## HISTORIC AND DESIGN REVIEW COMMISSION

April 03, 2019

**HDRC CASE NO:** 2019-156  
**ADDRESS:** 422 MUNCEY  
**LEGAL DESCRIPTION:** NCB 1655 BLK C LOT S 40 FT OF N 140 FT OF 13 & S 48.8 FT OF N 140 FT OF 14  
**ZONING:** R-5, H  
**CITY COUNCIL DIST.:** 2  
**DISTRICT:** Dignowity Hill Historic District  
**APPLICANT:** Michael Patula/Patula Properties, LLC  
**OWNER:** Juan LEIJA/Patula Properties, LLC  
**TYPE OF WORK:** Construction of a rear addition, exterior modifications, roof replacement  
**APPLICATION RECEIVED:** March 18, 2019  
**60-DAY REVIEW:** May 17, 2019  
**CASE MANAGER:** Edward Hall  
**REQUEST:**

# PLOT PLAN FOR BUILDING PERMITS

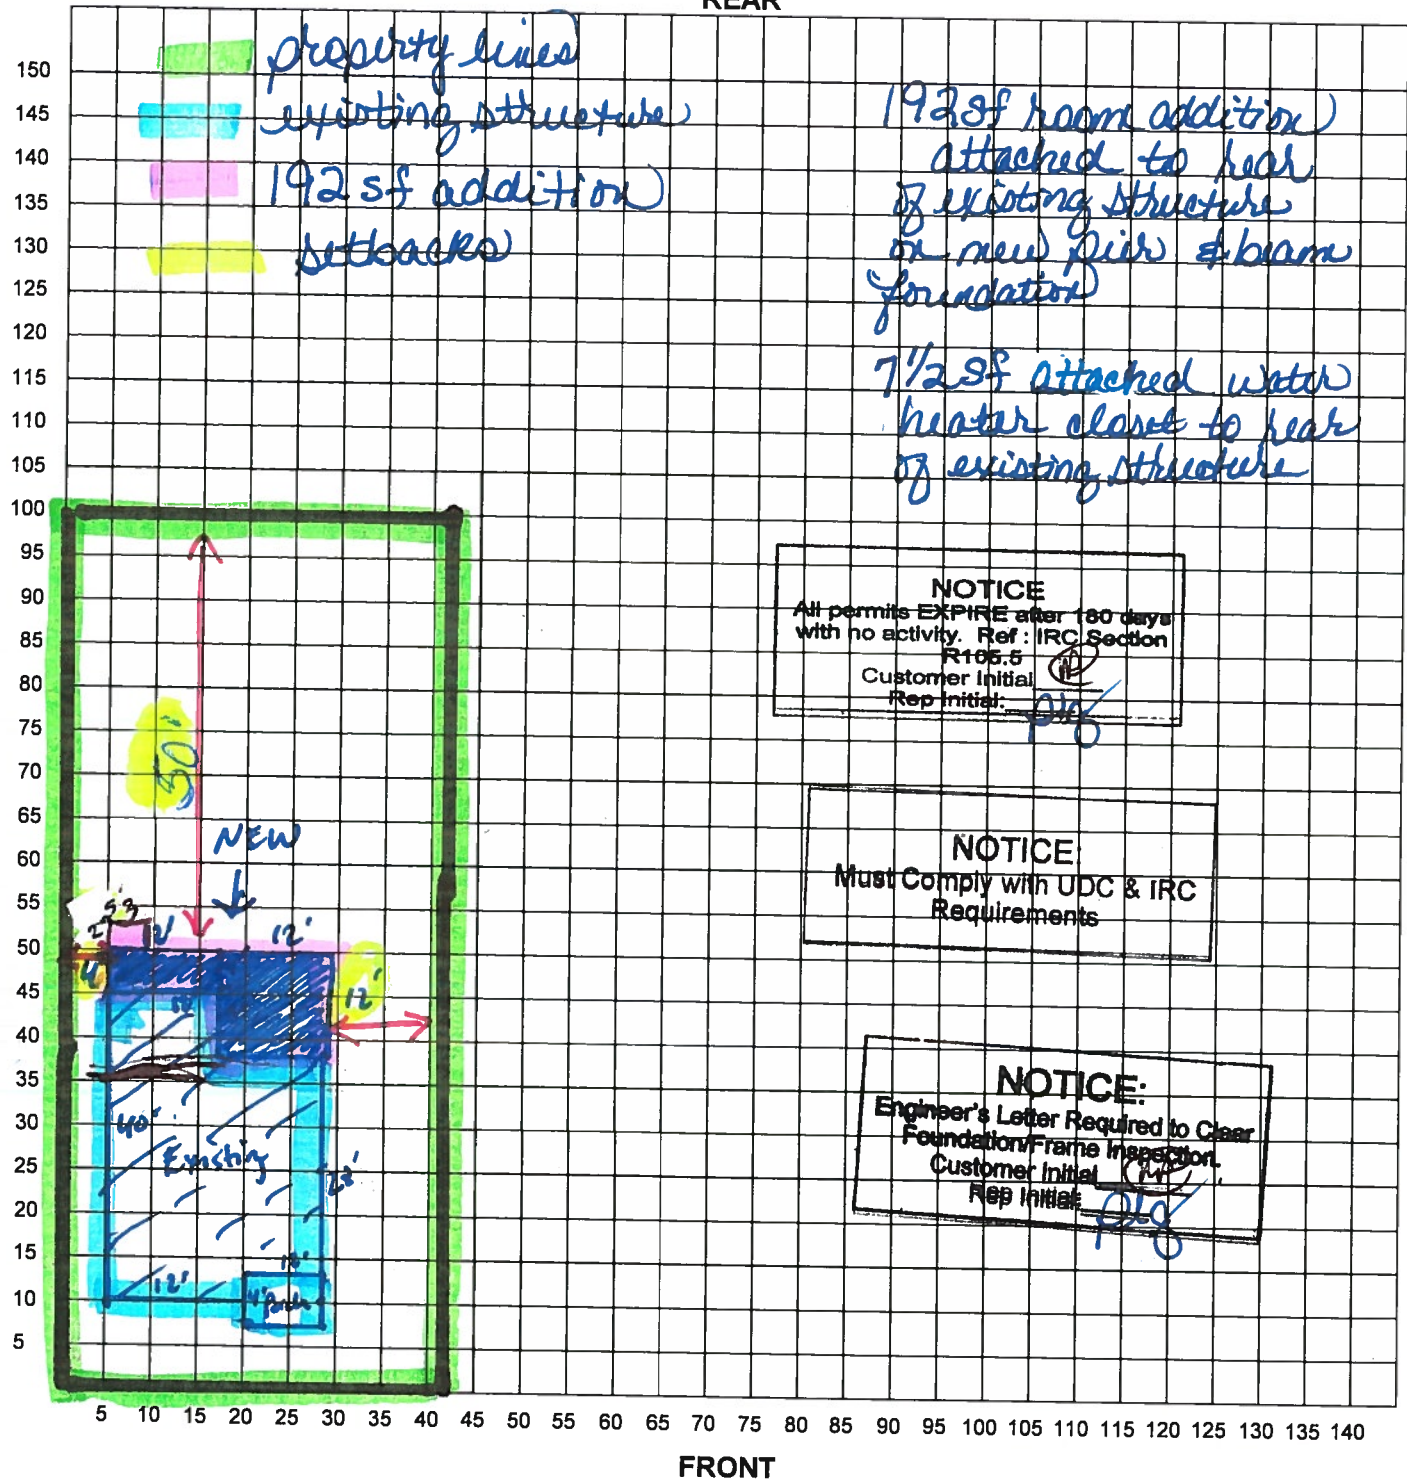
- e. **ADDITION** – The applicant has proposed to construct a one-story, rear addition to feature approximately 192 square feet. The Guidelines for Additions 1.A. states that additions should be sited to minimize visual impact from the public right of way, should be designed to be in keeping with the historic context of the block, should utilize a similar roof form and should feature a transition between the old and the new. The applicant has proposed a rear addition that features both a rear gabled roof and a low sloped, rear shed roof. The applicant has proposed for the rear addition to feature a wall plane that is consistent with that of the historic structure. Staff finds that a vertical trim piece should be incorporated into the design to visually separate the proposed addition from the historic structure.

4. Staff recommends approval of item #4, the construction of a rear addition based on findings e through i with the following stipulations:
  - i. That the applicant propose a vertical trim piece to separate the proposed addition from the historic structure.

422 Muncey

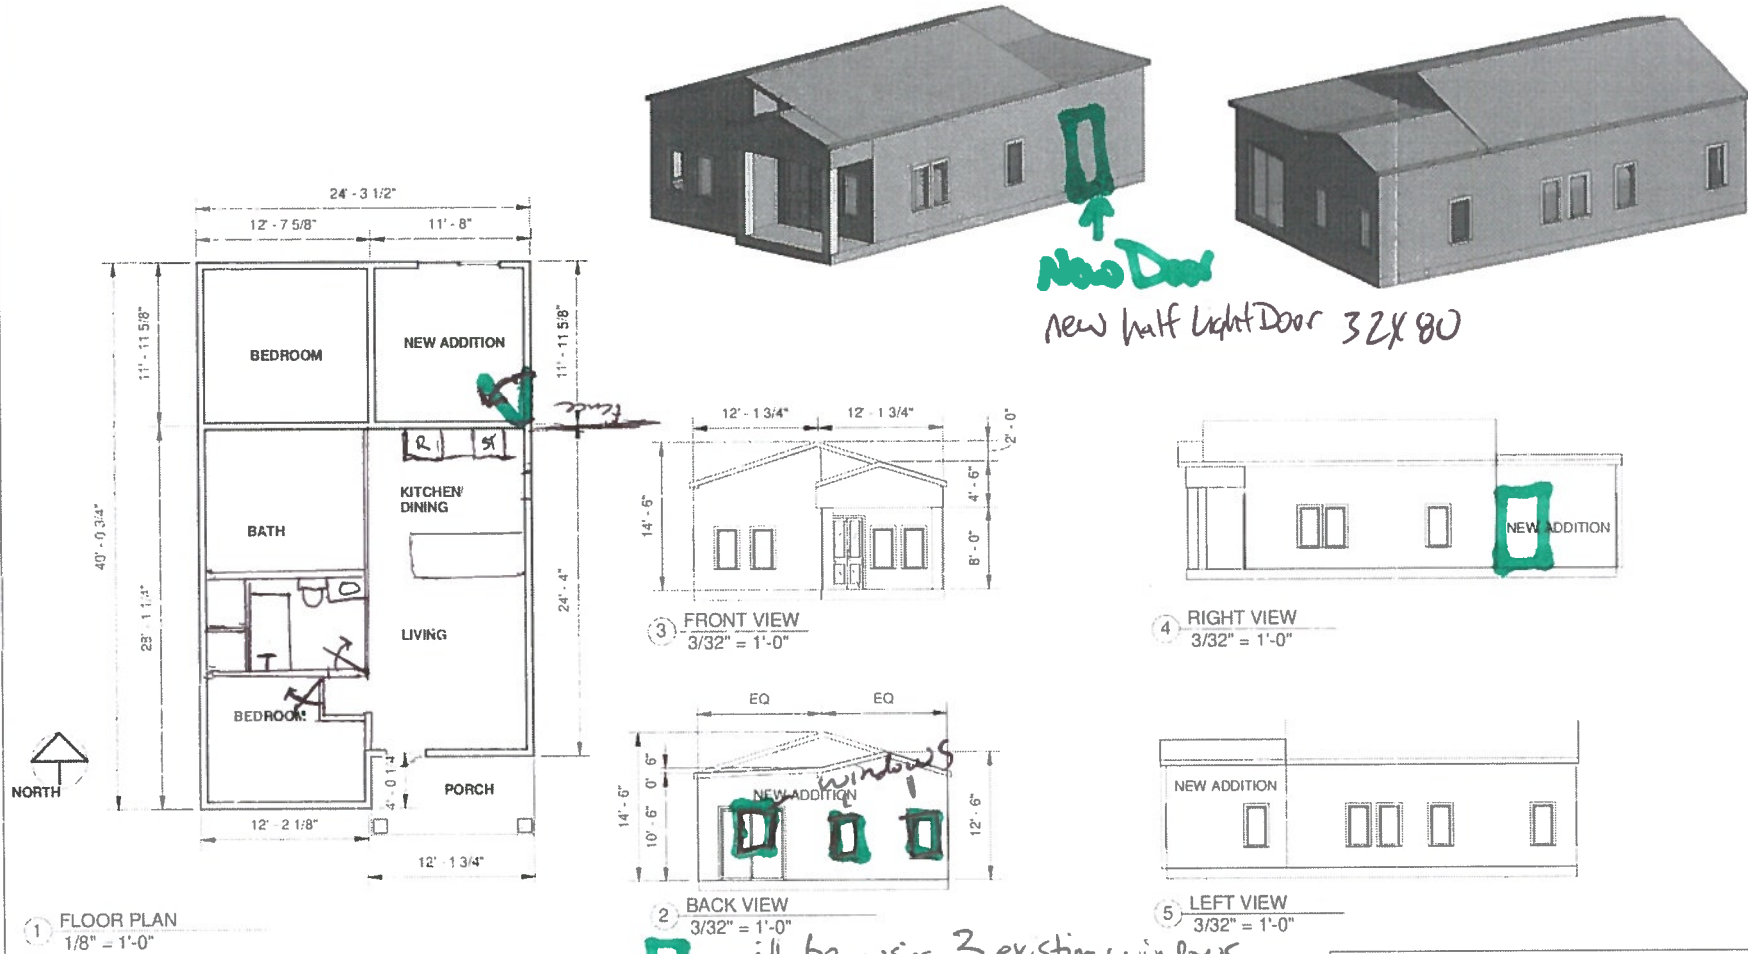
- f. **ROOF FORM** – The Guidelines for Additions 1.B.iii. notes that dormers should be compatible in size, scale, proportion, placement and detail with the style of the house and should be located on non-primary facades. The applicant has proposed both a gabled roof and a shed roof..

- g. **HEIGHT** – The applicant has proposed for the addition to feature a height that does not exceed that of the historic structure. The proposed addition's height is consistent with the Guidelines.

- h. **MATERIALS** – The applicant has noted that similar materials will be used on the proposed addition. Staff finds that #117 siding should be used to match that found on the historic structure. Additionally, staff finds that wood windows, wood trim and a standing seam metal roof should be used. The proposed windows should feature an inset of two (2) inches within facades. Meeting rails should be no taller than 1.25" and stiles no wider than 2.25". White manufacturer's color is not allowed, and color selection must be presented to staff. There should be a minimum of two inches in depth between the front face of the window trim and the front face of the top window sash. This must be accomplished by recessing the window sufficiently within the opening or with the installation of additional window trim to add thickness. Window trim must feature traditional dimensions and an architecturally appropriate sill detail. Window track components must be painted to match the window trim or concealed by a wood window screen set within the opening. Additionally, the proposed roof should feature specifications that match those noted in finding c.

- i. **ARCHITECTURAL DETAILS** – Generally the proposed addition features architectural details that are consistent with those of the historic structure; however, staff finds that a vertical trim piece should be utilized for the proposed addition to separate it from the historic structure.

- ii. That the applicant install wood windows that feature an inset of two (2) inches within facades. Meeting rails should be no taller than 1.25" and stiles no wider than 2.25". White manufacturer's color is not allowed, and color selection must be presented to staff. There should be a minimum of two inches in depth between the front face of the window trim and the front face of the top window sash. This must be accomplished by recessing the window sufficiently within the opening or with the installation of additional window trim to add thickness. Window trim must feature traditional dimensions and an architecturally appropriate sill detail. Window track components must be painted to match the window trim or concealed by a wood window screen set within the opening. Additionally, the proposed roof should feature specifications that match those noted in finding c.
